BRAUM'S ADDITION

SITE & GRADING PLAN
B.J.T. LEWIS SURVEY, ABSTRACT NO. 225
CITY OF ROCKWALL, ROCKWALL COUNTY, TEXAS

BRAUM'S SITE PLAN
ADDITIONAL INFORMATION

Agenda Item: P&Z 91-20/SP/FP/CUP - Hold Public Hearing and Consider Recommending Approval of a Request from Braum's for a Conditional Use Permit for a Structure with Less than 90% Exterior Masonry Facade, a Site Plan and Final Plat on a Tract of land Located on Yellowjacket and SH-205

Agenda Item: Braum's Site Plan and Plat

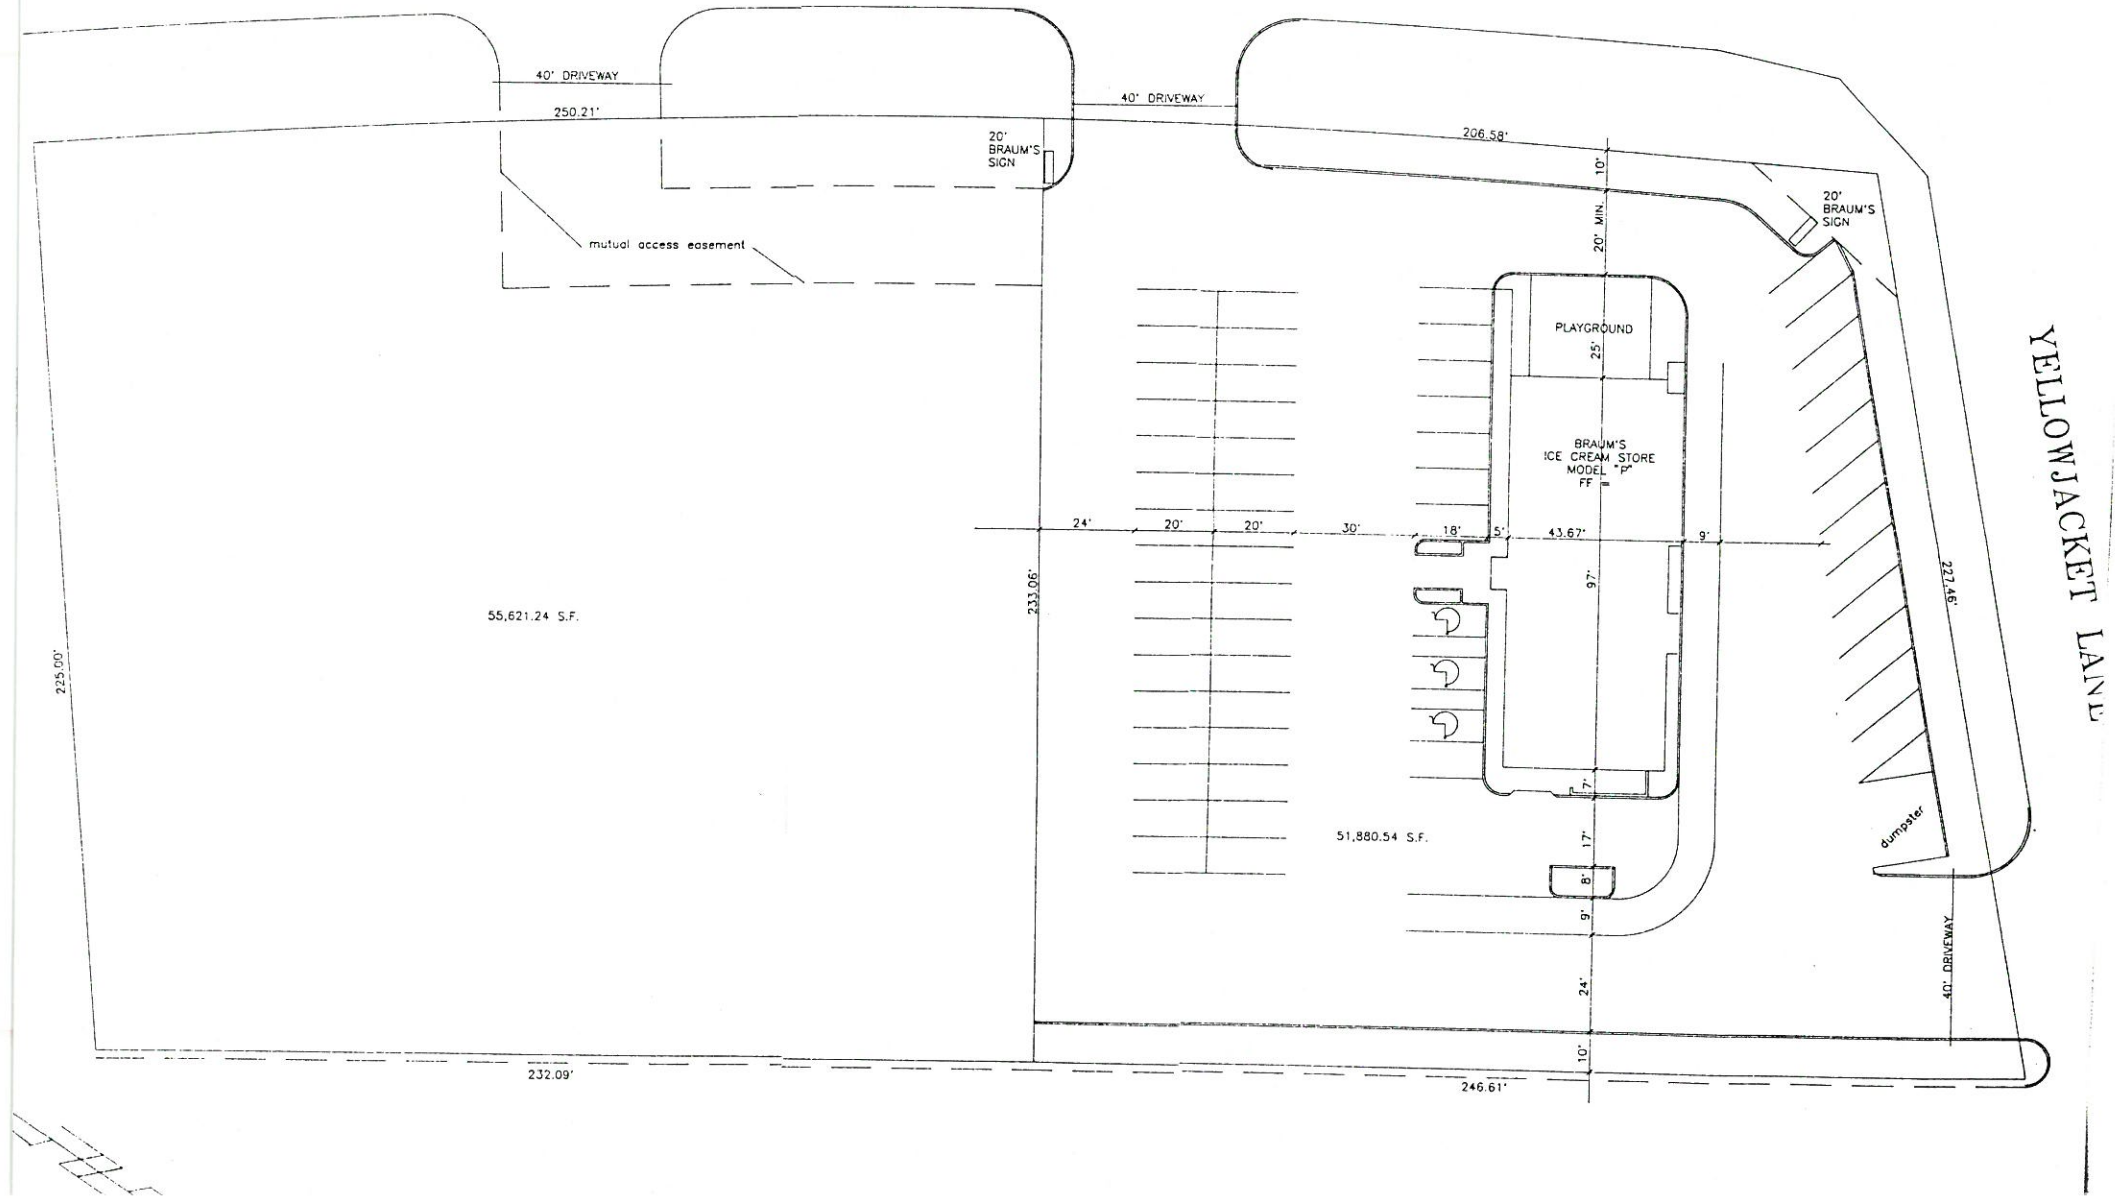
Signage - they are limited to one free standing sign not exceeding 20' in height and 60 sq. ft. in area. The plan shows two free standing signs.

Building Location - The building and the angle parking along the south property line are too close together for two way traffic. This drive would need to be signed as one way.

1. The two entrances onto SH-205 are located approximately 100 feet apart. Our current standards require that drives be located at least 200 feet apart unless a waiver is granted. The entrances are also unusually wide for the type of traffic that will be generated with the development. It was recommended to them that they consider a configuration of two 30' driveways approximately 150' apart and with the drive closest to Yellowjacket located approximately 150' from the intersection. The radius dimensions on the drives were also requested. It was also recommended that they be at least 20'. It was pointed out that when SH-205 is widened there is no median opening planned for this site.

2. It was recommended that the entrance off of Yellowjacket be reduced from 40 feet. As shown the outside radius of this entrance will conflict with the radius of the adjacent driveway into the apartments. Again, there is no median opening planned for this area when the road is widened to a 4 lane divided section.

NOTES FOR BRAUM'S CONT'D.

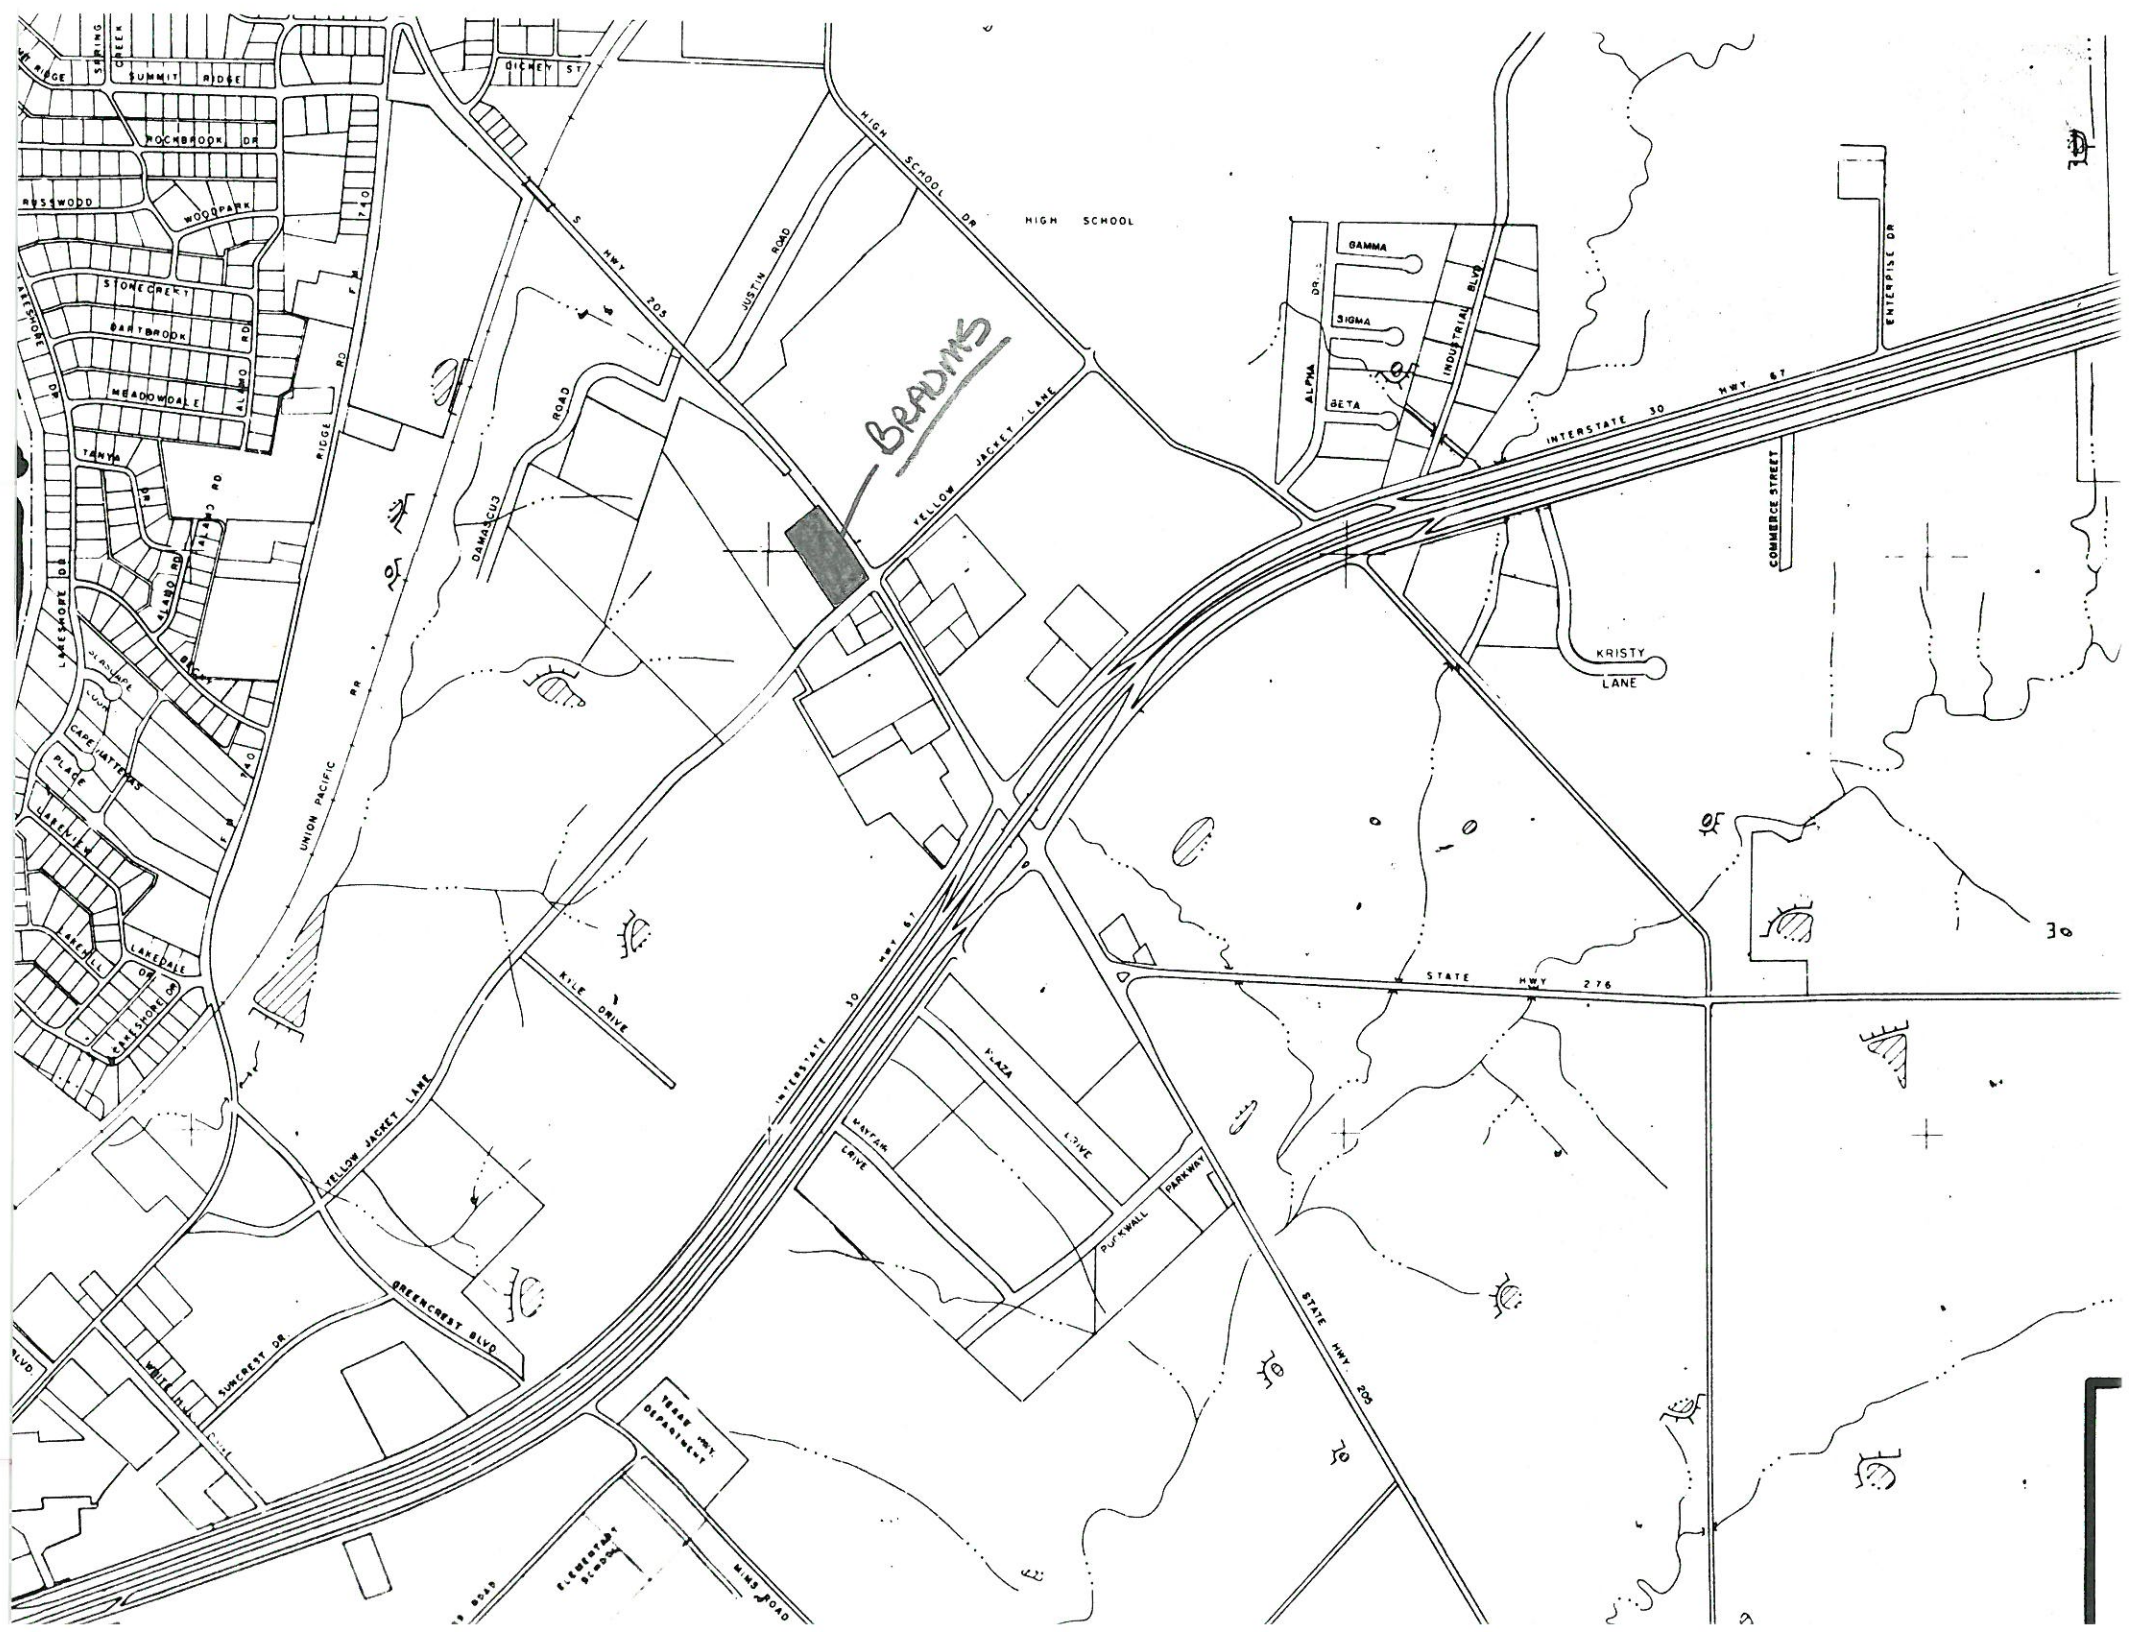
Building Location - The building and the angle parking along the south property line are too close together for two way traffic. This drive would need to be signed as one way.

1. The two entrances onto SH-205 are located approximately 150 feet apart. Our current standards require that drives be located at least 200 feet apart unless a waiver is granted. It was pointed out that when SH-205 is widened there is no median opening planned for this site.
2. It was recommended that the entrance off of Yellowjacket be reduced from 40 feet. As shown the outside radius of this entrance will conflict with the radius of the adjacent driveway into the apartments. Again, there is no median opening planned for this area when the road is widened to a 4 lane divided section.
